JANUARY 13, 2014

CITY OF PORTLAND
DRAFT Facility Report
Bureau of Transportation

THIRD FLOOR

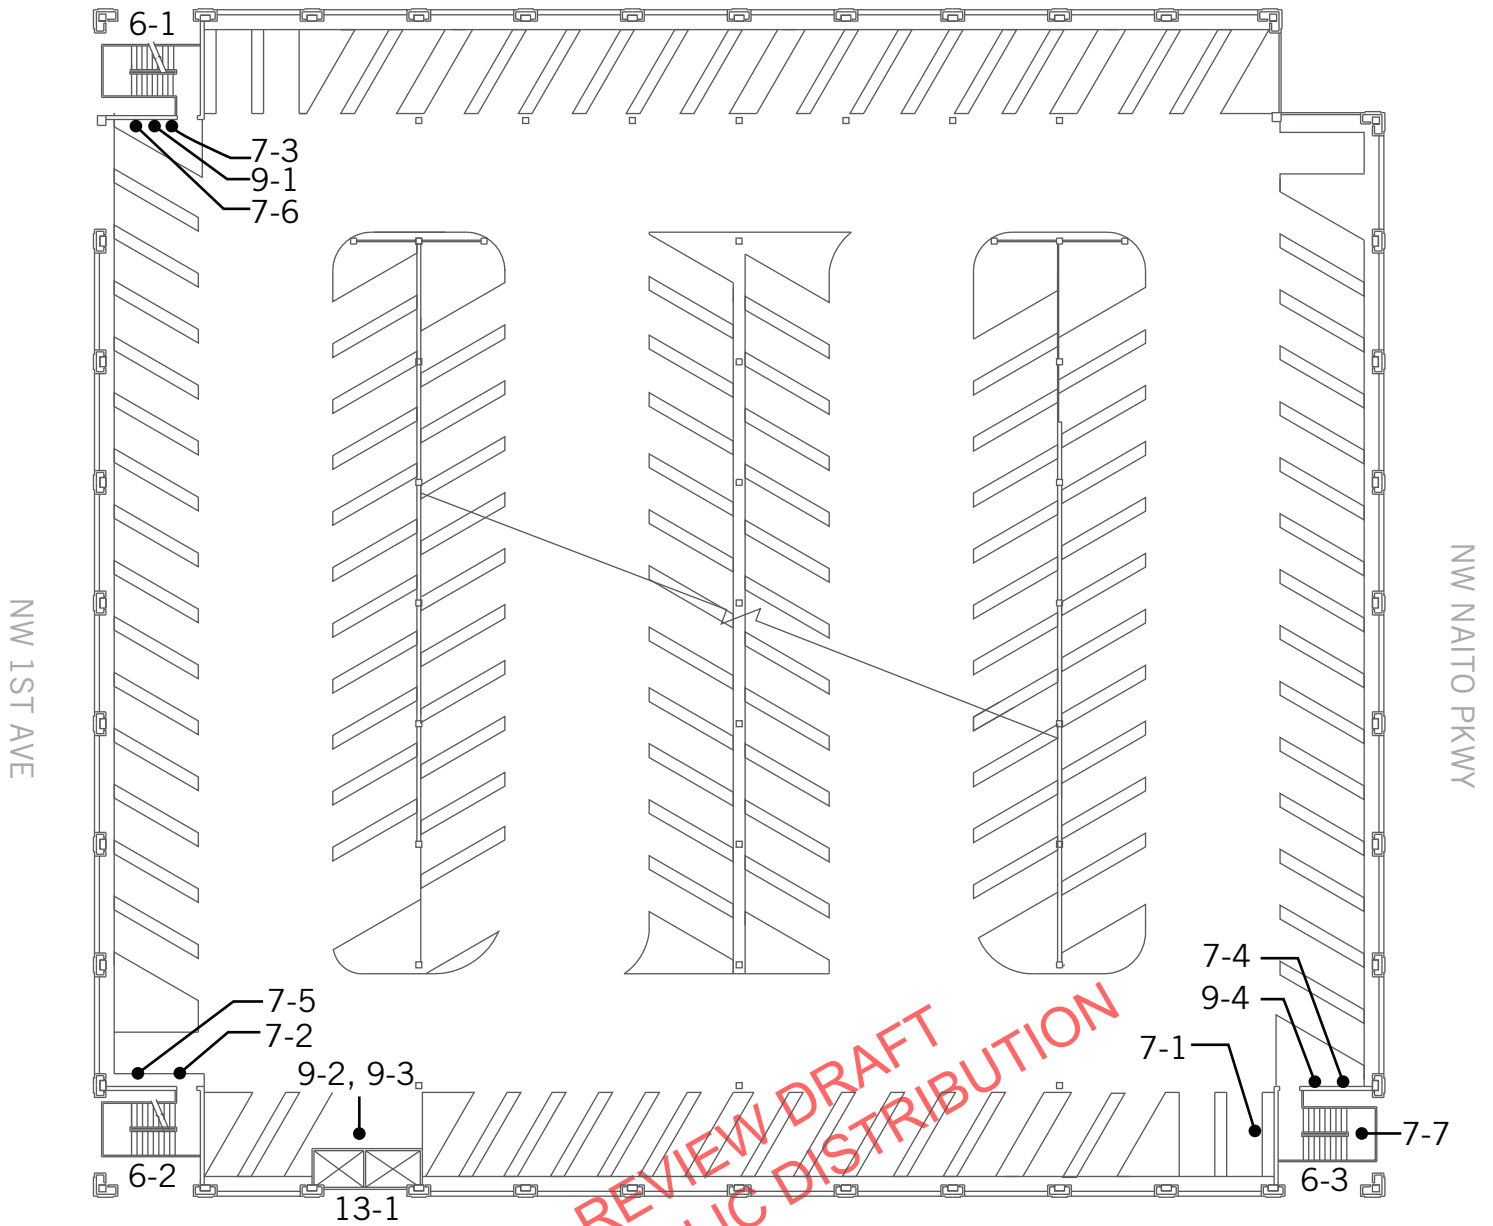
Floor 3	
6 - 1	Stairway
Category:	
Replace stairs	\$1,500
Notes: Stairway 3rd to 4th floor has 18 risers and two stair runs (9 and 9 risers). On the lower stair run, slopes of two treads are 3.0% and 3.1% and three of the treads on the upper run are 2.6% to 3.0% (2.0% max).	
State: ---	
Federal: 504.4	
Install a handrail	\$375
Notes: A parallel extension is not provided at the top of the handrail on one side of the stairway (12" min) on both the upper and lower stair run. On the upper stair run a sloped extension is not provided at the bottom of the handrail on one side of the stairway (one tread-width min).	
State: ---	
Federal: 505.10.2, 505.10.3	
Raise or lower existing handrail	\$1,800
Notes: Handrail top surface is mounted 31" to 32-3/4" above the stair nosing (34" min to 38" max).	
State: ---	
Federal: 505.4	
Install or modify stairway signage	\$500
Notes: Floor level sign does not state the terminus of the exit enclosure or the story of and the direction to the exit discharge (signs provided at each floor landing in an exit enclosures connecting more than three stories). Sign is 15-1/4" square (18" by 12" min). Lettering identifying the stair enclosure is 1" to 1-3/8" (1-1/2" min). Sign is located in the intermediate landing of the stairway (sign located on each floor landing). A tactile and Braille EXIT sign is not provided.

Floor 3	
6 - 2	Stairway
Category:	
Install a handrail	\$375
<p>Notes: Stairway 3rd to 4th floor has 18 risers and two stair runs (9 and 9 risers). A parallel extension is not provided at the top of the handrail on one side of the stairway (12" min) on both the upper and lower stair runs. Sloped handrail extension of 10-5/8" is provided on one side of the bottom of the lower stair run (one tread-width min).</p>	
<p>State: ---</p> <p>Federal: 505.10.2, 505.10.3</p>	
Raise or lower existing handrail	\$1,800
<p>Notes: Handrail top surface is mounted 31-1/4" to 32-1/2" above the stair nosing (34" min to 38" max).</p>	
<p>State: ---</p> <p>Federal: 505.4</p>	
Install or modify stairway signage	\$500
<p>Notes: Floor level sign does not state the terminus of the exit enclosure or the story of and the direction to the exit discharge (signs provided at each floor landing in an exit enclosures connecting more than three stories). Sign is 15-1/4" square (18" by 12" min). Lettering identifying the stair enclosure is 1" to 1-3/8" (1-1/2" min). Sign is located in the intermediate landing of the stairway (sign located on each floor landing). A tactile and Braille EXIT sign is not provided.</p>

Floor 3		6 - 3	Stairway	Category:
Replace stairs				\$300
Notes: Stairway 3rd to 4th floor has 18 risers and two stair runs (9 and 9 risers). The slope of the second tread from top on bottom stair run is 3.3% (2.0% max).				
State: ---				
Federal: 504.4				
Install a handrail				\$375
Notes: A parallel extension is not provided at the top of the handrail on one side of the stairway (12" min) on the lower stair run, and no parallel extensions are provided at the top of the upper stair run.				
State: ---				
Federal: 505.10.2				
Raise or lower existing handrail				\$1,800
Notes: Handrail top surface is mounted 31-1/8" to 32-3/8" above the stair nosing (34" min to 38" max).				
State: ---				
Federal: 505.4				
Install or modify stairway signage				\$500
Notes: Floor level sign does not state the terminus of the exit enclosure or the story of and the direction to the exit discharge (signs provided at each floor landing in an exit enclosures connecting more than three stories). Sign is 15-1/4" square (18" by 12" min). Lettering identifying the stair enclosure is 1" to 1-3/8" (1-1/2" min). Sign is located in the intermediate landing of the stairway (sign located on each floor landing). A tactile and Braille EXIT sign is not provided.

State: ---, 1022.8, 1022.8.1, 1110.2				
Federal: ---, 216.4.1				
7 - 1	Hazard	Category:		
Remove overhanging or protruding objects				\$125
Notes: Fire extinguisher protrudes 6-1/2" from wall at 32-1/4" AFF (protrusion more than 4" must be mounted below 27" or above 80").				
State: ---				
Federal: 307.2				
7 - 2	Hazard	Category:		
Remove overhanging or protruding objects				\$125
Notes: Fire extinguisher protrudes 6-1/2" from wall at 30-3/8" AFF (protrusion more than 4" must be mounted below 27" or above 80").				
State: ---				
Federal: 307.2

Floor 3		
7 - 3	Hazard	Category:
Remove overhanging or protruding objects		\$125
Notes: Fire extinguisher protrudes 6-1/2" from wall at 32-5/8" AFF (protrusion more than 4" must be mounted below 27" or above 80").		
State: ---		
Federal: 307.2		
7 - 4	Hazard	Category:
Remove overhanging or protruding objects		\$125
Notes: Water valve protrudes 12" from wall at 44-1/2" AFF (protrusion more than 4" must be mounted below 27" or above 80").		
State: ---		
Federal: 307.2		
7 - 5	Hazard	Category:
Remove overhanging or protruding objects		\$125
Notes: Water valve protrudes 13" from wall at 45" AFF (protrusion more than 4" must be mounted below 27" or above 80").		
State: ---		
Federal: 307.2		
7 - 6	Hazard	Category:
Remove overhanging or protruding objects		\$125
Notes: Water valve protrudes 12-1/2" from wall at 47-1/2" AFF (protrusion more than 4" must be mounted below 27" or above 80").		
State: ---		
Federal: 307.2

7 - 7	Hazard	Category:
Remove overhanging or protruding objects		\$375
Notes: Three utility boxes protrude 7-1/4" from wall at 54-1/4", 54-1/2" and 54-5/8" AFF (protrusion more than 4" must be mounted below 27" or above 80").		
State: ---		
Federal: 307.2

Floor 3	
9 - 1	Sign Category:
Relocate existing sign	\$125
Notes: "Smart Park Level 3" sign lettering is 37-5/8" above the ground (40" min).	
State: ---	
Federal: 703.5.6	
Install or modify permanent room sign	\$250
Notes: "Smart Park Level 3" sign has a high gloss finish (non-glare finish).	
State: ---	
Federal: 703.5.1	
9 - 2	Sign Category:
Relocate existing sign	\$125
Notes: "Attention!" sign lettering is 39" above the ground (40" min).	
State: ---	
Federal: 703.5.6	
9 - 3	Sign Category:
Relocate existing sign	\$125
Notes: "Smart Park Level 3" sign lettering is 36-3/8" above the ground (40" min).	
State: ---	
Federal: 703.5.6	
Install or modify permanent room sign	\$250
Notes: "Smart Park Level 3" sign has a high gloss finish (non-glare finish).	
State: ---	
Federal: 703.5.1	
9 - 4	Sign Category:
Relocate existing sign	\$125
Notes: "Smart Park Level 3" sign lettering is 37-7/8" above the ground (40" min).	
State: ---

Federal: 703.5.6	
Install or modify permanent room sign	\$250
Notes: "Smart Park Level 3" sign has a high gloss finish (non-glare finish).	
State: ---	
Federal: 703.5.1

Floor 3	
13 - 1 Elevator	Category:
Adjust or provide elevator signals and indicators	\$2,500
Notes: Hallway call buttons do not indicate when the call is registered and answered on Level 3.	
State: ---	
Federal: 407.2.1.5

33 NW DAVIS AVENUE, PORTLAND OR
FOURTH FLOOR

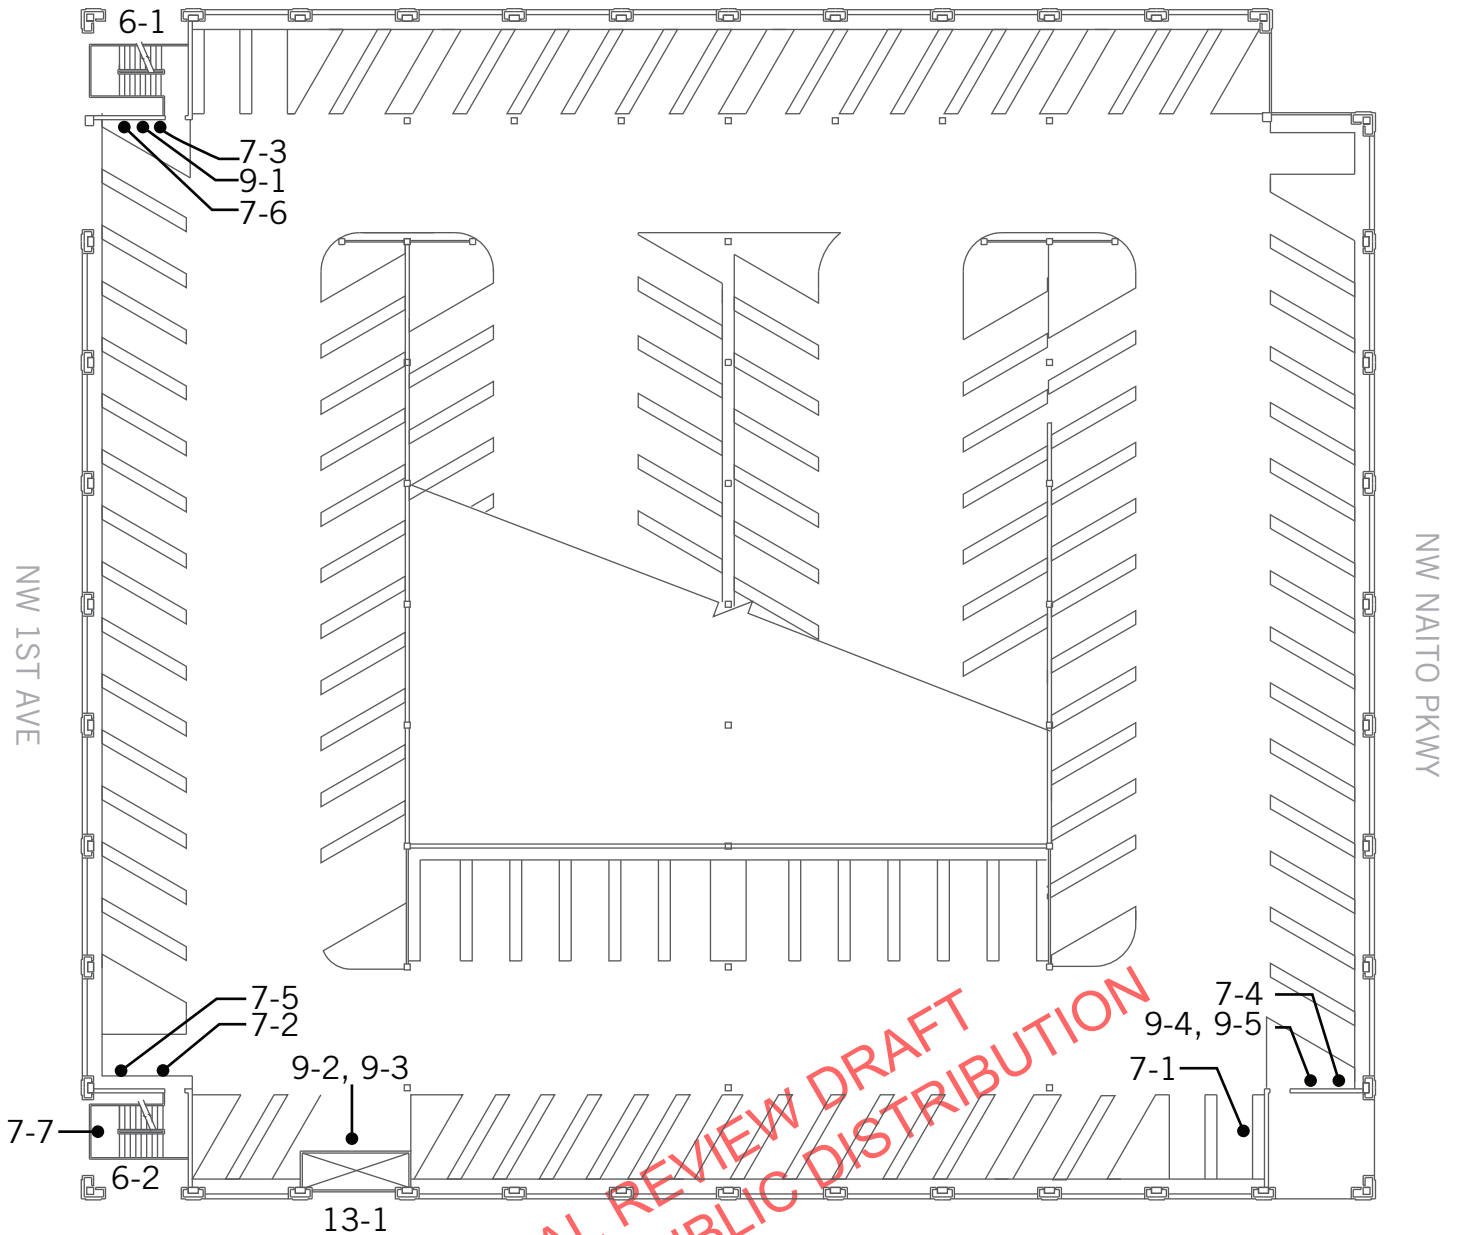
Floor 4		Category:
6 - 1	Stairway	
Replace stairs		\$3,900
Notes: Stairway 4th to 5th floor has 18 risers and two stair runs (9 and 9 risers). On the lower stair run the slopes of four treads range from 2.3% to 2.8%, and on the upper stair run one tread has a slope of 2.3% (2.0% max). Tread widths on the upper run range from 10-3/4" to 10-7/8" from riser to riser (11" min).		
State: ---		
Federal: 504.2, 504.4		
Install a handrail		\$500
Notes: A parallel extension is not provided at the top of the handrail on one side of the stairway (12" min) on the lower stair run, and no parallel extensions are provided at the top of the upper stair run. A sloped handrail extension is not provided at the bottom of the handrail on one side of the lower stair run (one tread-width min).		
State: ---		
Federal: 505.10.2, 505.10.3		
Raise or lower existing handrail		\$1,800
Notes: Handrail top surface is mounted 31" to 32" above the stair nosing (34" min to 38" max).

State: ---		
Federal: 505.4		
Install or modify stairway signage		\$500
Notes: Floor level sign does not state the terminus of the exit enclosure or the story of and the direction to the exit discharge (signs provided at each floor landing in an exit enclosures connecting more than three stories). Sign is 15-1/4" square (18" by 12" min). Lettering identifying the stair enclosure is 1" to 1-3/8" (1-1/2" min). Sign is located in the intermediate landing of the stairway (sign located on each floor landing). A tactile and Braille EXIT sign is not provided.		
State: ---, 1022.8, 1022.8.1, 1110.2		
Federal: ---, 216.4.1

Notes: Stairway 4th to 5th floor has 18 risers and two stair runs (9 and 9 risers). On the lower stair run the slopes of three treads range from 2.6% to 3.7%, and on the upper stair run five treads have slopes from 2.6% to 4.7% (2.0% max). On the upper stair run, the bottom riser height is 5-1/2", while others are 6-1/4" to 6-1/2" in height (uniform heights req).

Notes: A parallel extension is not provided at the top of the handrail on one side of the stairway (12" min) on both the upper and lower stair runs.

Notes: Handrail top surface is mounted 31-1/4" to 32" above the stair nosing (34" min to 38" max).

Notes: Floor level sign does not state the terminus of the exit enclosure or the story of and the direction to the exit discharge (signs provided at each floor landing in an exit enclosures connecting more than three stories). Sign is 15-1/4" square (18" by 12" min). Lettering identifying the stair enclosure is 1" to 1-3/8" (1-1/2" min). Sign is located in the intermediate landing of the stairway (sign located on each floor landing). A tactile and Braille EXIT sign is not provided.

Notes: Fire extinguisher protrudes 6-1/2" from wall at 32-3/4" AFF (protrusion more than 4" must be mounted below 27" or above 80").

Floor 4		
7 - 2	Hazard	Category:
Remove overhanging or protruding objects		\$125
Notes: Fire extinguisher protrudes 6-1/2" from wall at 32-1/4" AFF (protrusion more than 4" must be mounted below 27" or above 80").		
State: ---		
Federal: 307.2		
7 - 3	Hazard	Category:
Remove overhanging or protruding objects		\$125
Notes: Fire extinguisher protrudes 6-1/2" from wall at 30" AFF (protrusion more than 4" must be mounted below 27" or above 80").		
State: ---		
Federal: 307.2		
7 - 4	Hazard	Category:
Remove overhanging or protruding objects		\$125
Notes: Water valve protrudes 13" from wall at 35-1/2" AFF (protrusion more than 4" must be mounted below 27" or above 80").		
State: ---		
Federal: 307.2		
7 - 5	Hazard	Category:
Remove overhanging or protruding objects		\$125
Notes: Water valve protrudes 13" from wall at 45" AFF (protrusion more than 4" must be mounted below 27" or above 80").		
State: ---		
Federal: 307.2

7 - 6	Hazard	Category:
Remove overhanging or protruding objects		\$125
Notes: Water valve protrudes 12" from wall at 45" AFF (protrusion more than 4" must be mounted below 27" or above 80").		
State: ---		
Federal: 307.2		
7 - 7	Hazard	Category:
Remove overhanging or protruding objects		\$250
Notes: Two utility boxes protrude 7-1/4" from wall at 52-3/4" and 53-1/4" AFF (protrusion more than 4" must be mounted below 27" or above 80").		
State: ---		
Federal: 307.2

Notes: "Smart Park Level 4" sign lettering is 38" above the ground (40" min).

Notes: "Smart Park Level 4" sign has a high gloss finish (non-glare finish).

Notes: "Smart Park Level 4" sign lettering is 37-7/8" above the ground (40" min).

Notes: "Smart Park Level 4" sign has a high gloss finish (non-glare finish).

Notes: "Attention!" sign lettering is 38-7/8" above the ground (40" min).

Notes: "Take Ticket with You" sign lettering is 27-1/2" above the ground (40" min).

Notes: "Smart Park Level 4" sign lettering is 37-1/8" above the ground (40" min).

Notes: "Smart Park Level 4" sign has a high gloss finish (non-glare finish).

Floor 4	
13 - 1 Elevator	Category:
Increase or provide clear floor space	\$1,000
Notes: Slope of the clear floor space at the hall call buttons is 3.1% (2.0% max) on Level 4.	
State: ---	
Federal: 305.2, 407.2.1.3	
Adjust or provide elevator signals and indicators	\$2,500
Notes: Hallway call buttons do not indicate when the call is registered and answered on Level 4.	
State: ---	
Federal: 407.2.1.5

BOT-10: O'BRYANT SQUARE GARAGE
SW PARK AVENUE AND WASHINGTON STREET, PORTLAND OR

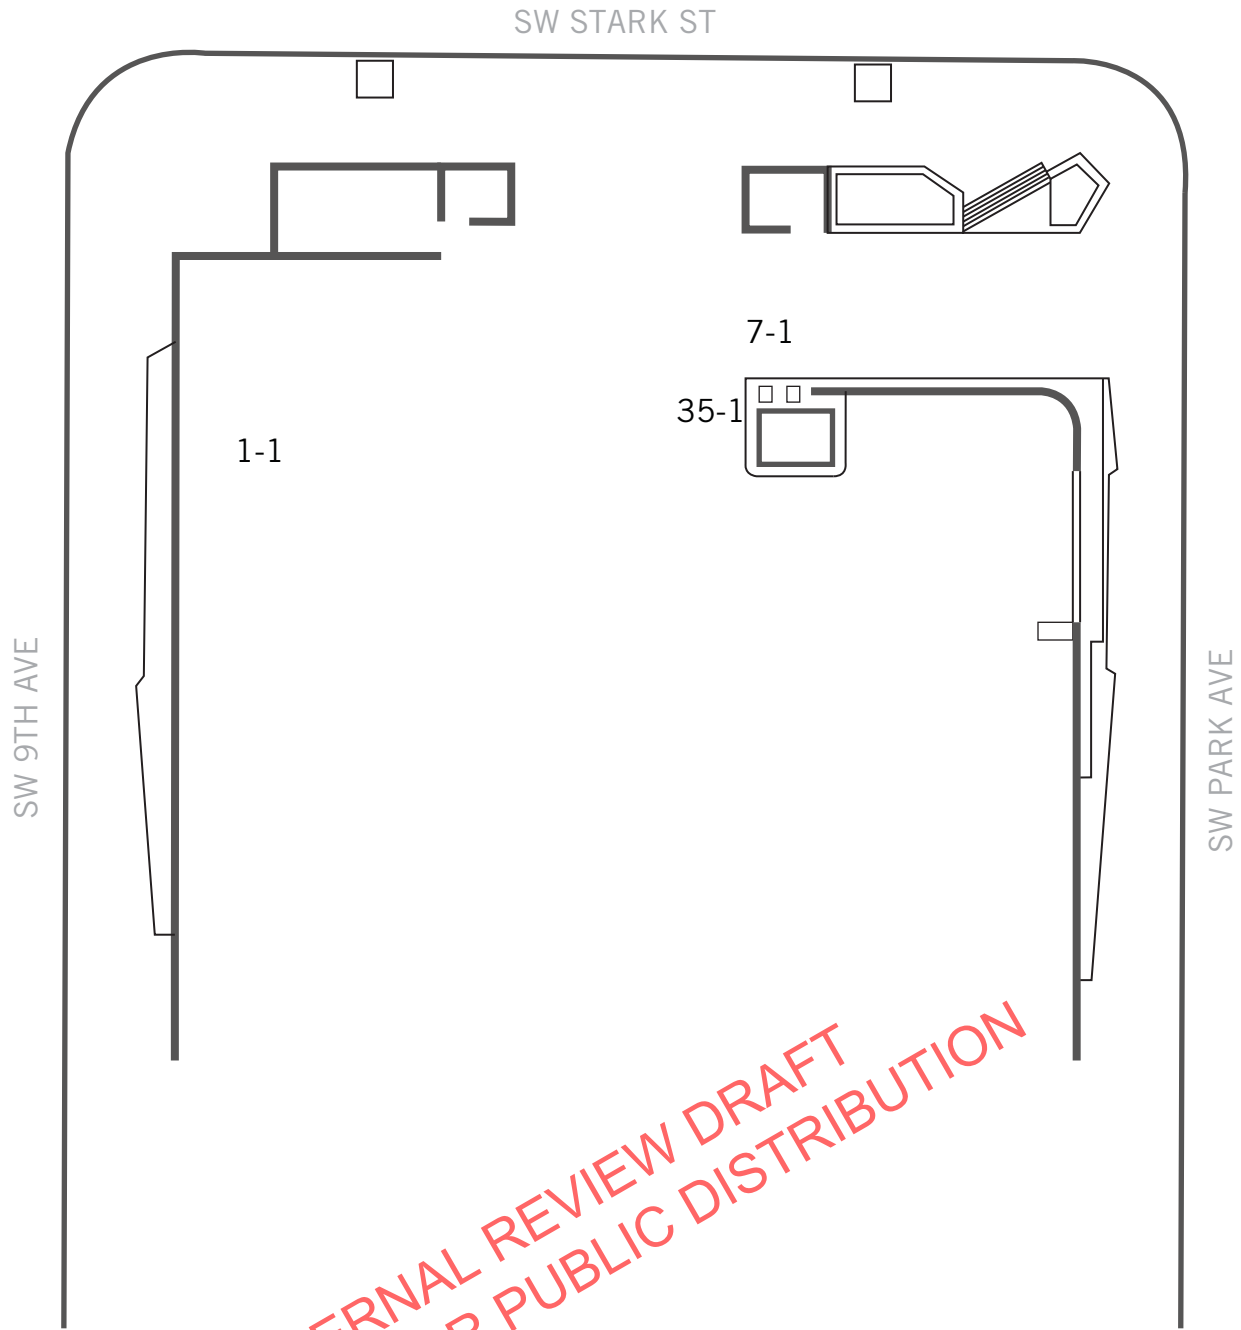
1 - 1	Parking Area	Category:
Provide an accessible path of travel		\$3,120
Notes: There is not an accessible route to or from the accessible parking space. At the time of survey the designated accessible parking space was surrounded by cars on both sides and to its front, including a car parked in the access aisle. A passenger loading zone is not provided at this parking facility. Route from the designated accessible space to the ticket kiosk has a running slope up to 8.3% for 49 linear feet (5.0% max). Route from the ticket kiosk to SW Stark St is 26 linear feet with a running slope up to 12.3% (5.0% max). Route from ticket kiosk to SW Park Ave has a running slope up to 12.3% (5.0% max) and a cross slope up to 14.7% (2.0% max) for 29 linear feet and is obstructed by a grate. See Hazard 7-1.		
State: ---		
Federal: 502.3		
Provide or modify accessible spaces		\$8,085
Notes: Parking area has 90 spaces with one designated accessible space (4 spaces min for 76 to 100 spaces). There is no van accessible parking space (one van accessible parking min).

State: 1106.7.1		
Federal: 208.2.4		
Provide adequate striping		\$30
Notes: Accessible parking space is 8' 7-1/2" wide (9' min).		
State: 1106.7.1		
Federal: 502.2		
Regrade parking space or access aisle		\$3,200
Notes: Slope of parking space and access aisle is up to 6.9% (2.0% max).		
State: 1106.7.1		
Federal: 502.4, 504.4		
Install reserved parking sign		\$375
Notes: Sign is 50-1/4" above the parking surface (60" min).		
State: 1106.71		
Federal: 502.6		
Remove overhanging or protruding objects		\$0
Notes: Vertical clearance measured at the front of the access aisle is 83-3/4" due to concrete support beam (98" min).		
State: -		
Federal: 502.5

7 - 1 Hazard		Category:
Install an accessible grate		\$500
Notes: Grate has two sections, one with openings 1-1/4" by 11-3/4", and another with openings 1" by 12" (1/2" max).		
State: ---		
Federal: 302.3		
35 - 1 Other		Category:
Increase or provide maneuvering or clear floor area		\$700
Notes: Clear floor space in front of the ticket kiosk a slope of 3.4% (2.0% max).		
State: ---		
Federal: 305.3, 305.5
